Item 5.**Development Application: 290-294 Botany Road, Alexandria - D/2026/162****File Number: D/2026/162****Summary**

Date of submission:	26 February 2026
Applicant:	Antoniades Architects
Architect/Designer:	Antoniades Architects
Owner:	Angreb Pty Ltd and Sentra Investments Pty Ltd
Planning consultant:	GSA Planning
Heritage consultant:	Weir Phillips Heritage
Cost of works:	\$53,185,000
Zoning:	MU1 Mixed-Use
Proposal summary:	The application is a proposal for concept approval (no physical works) comprising demolition of existing buildings, remediation of land, excavation of one level of basement with vehicular access from Wyndham Street, and an envelope up to 31.65 metres in height. Indicative future land uses comprise basement parking, services, plant, and storage, ground floor retail and co-living, and upper level co-living and services. The indicative reference scheme submitted with the application indicates that approximately 250 co-living rooms, 2 retail tenancies, 20 car parking spaces, 2 motorcycle parking spaces and 281 bicycle parking spaces could be accommodated within the proposed envelope. The development includes an offer to enter into a Voluntary Planning Agreement (

Figure 13: Concept envelope section identifying extent of Height of buildings variation to Botany Road

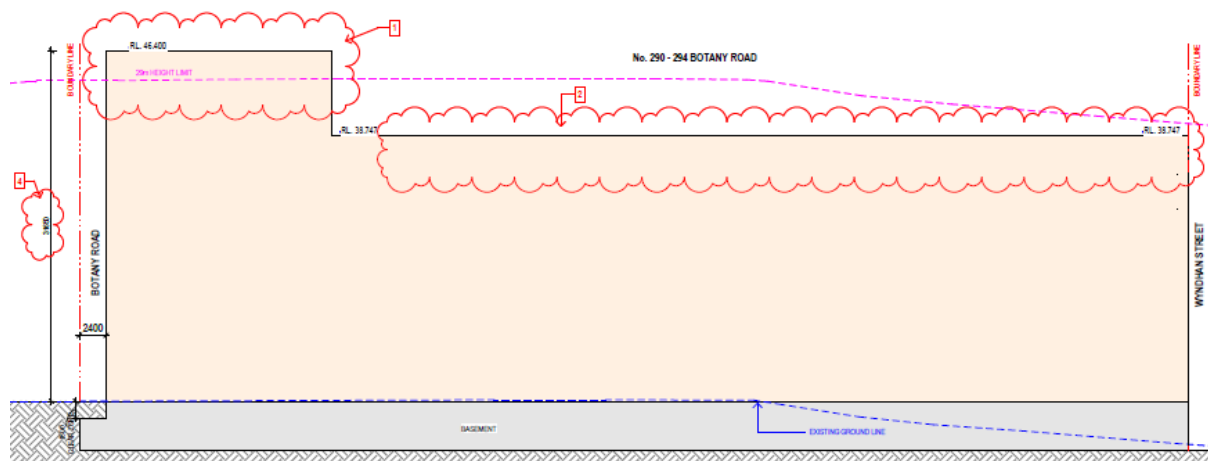
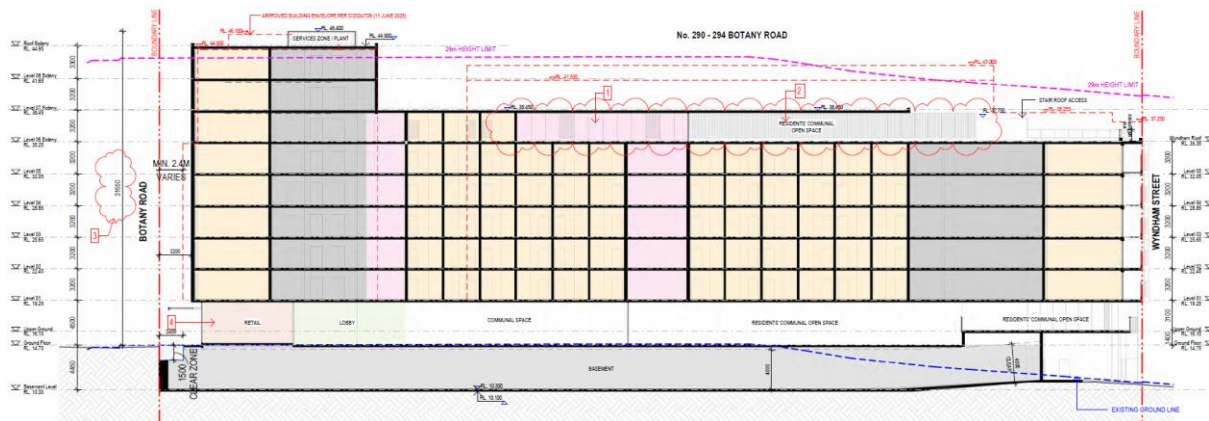
45. The site is subject to a maximum Height of buildings control of 29m. The proposed development has a maximum building height of 31.65m, being a variation of 2.65m or 9%.

- 50. For the reasons provided above the variation to the Height of buildings standard is supported as the applicant has demonstrated the matters required to be addressed by cl 4.6 of the Sydney Local Environmental Plan 2012.

Figure 15: Concept envelope elevation comparing proposed development to neighbouring development

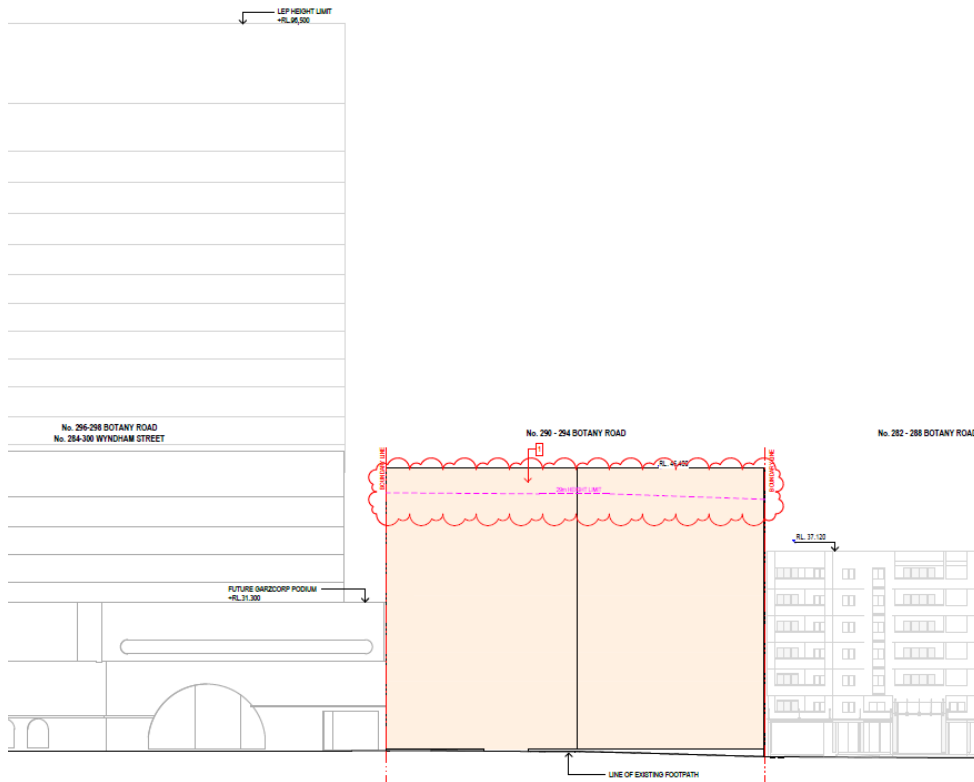
- (iii) The proposed development is substantially shorter than towers A and B of the approved development at 269-298 Botany Road, and is comparable and slightly shorter than the adjacent tower C.
